CERTIFICATE OF COMPLETION/OPERATION PERMIT

FILE: 884 A DATE: 5-19-94

Address of Property 11201 Cobb Rd.

INSTALLATION, CONSTRUCTION, ALTERATION, AND/OR REPAIR PERMIT

PLOT OF SYSTEM

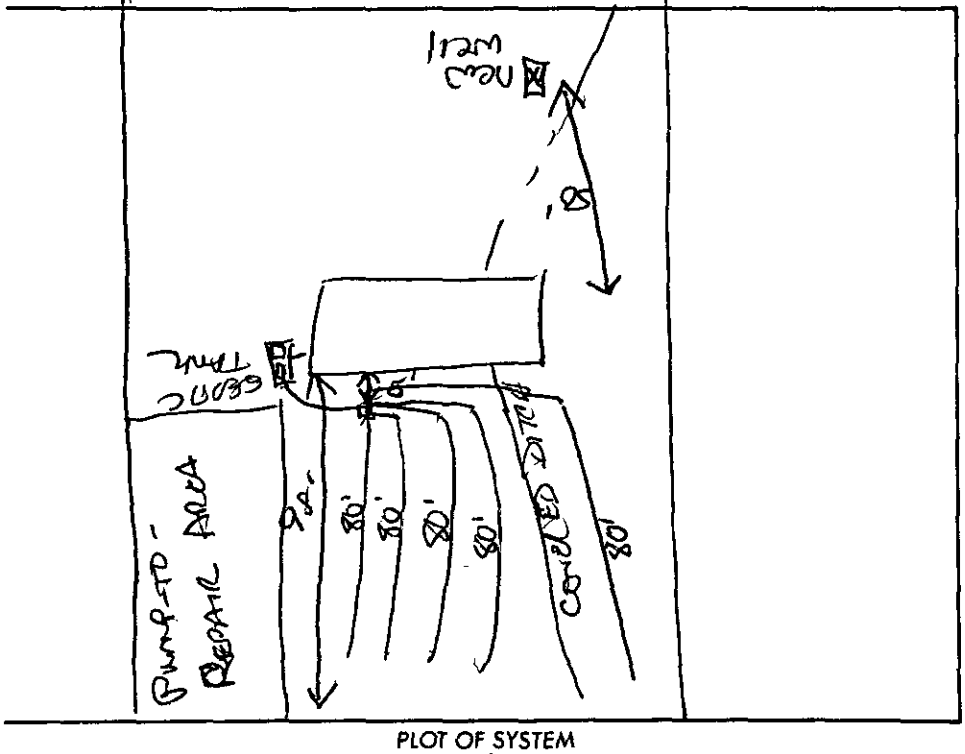
Comments: maximum trench 28", 6"-16" trench cover, well shall be 50' to 100' from any part of the septic tank system. Keep off covered ditch. Pump-to-conventional repair system moved to accomodate well installation.

PLOT OF SYSTEM

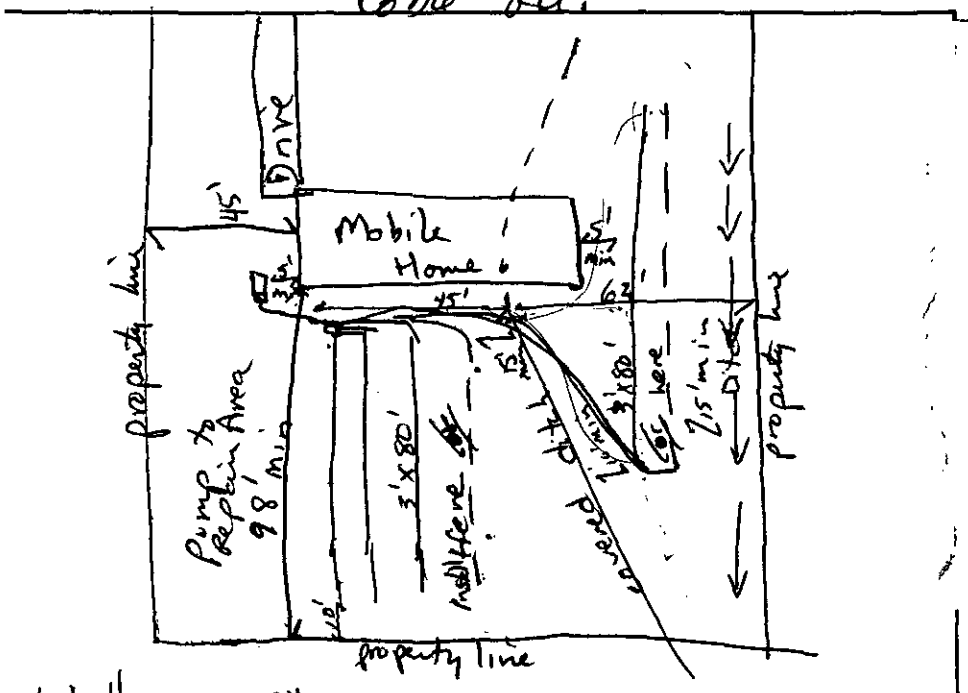
Property Line 10' min feet

Distance from Well 50' min feet preferably 100' min

(well not in yet)

6"-16" soil cover

trench bottom max 28"

Comments: Pump to Repair Area. Keep well min 50', preferably 100', from any part of septic system. Set mobile home to accomodate septic tank system. Keep off of covered ditch as shown. Some grading was done on lot.
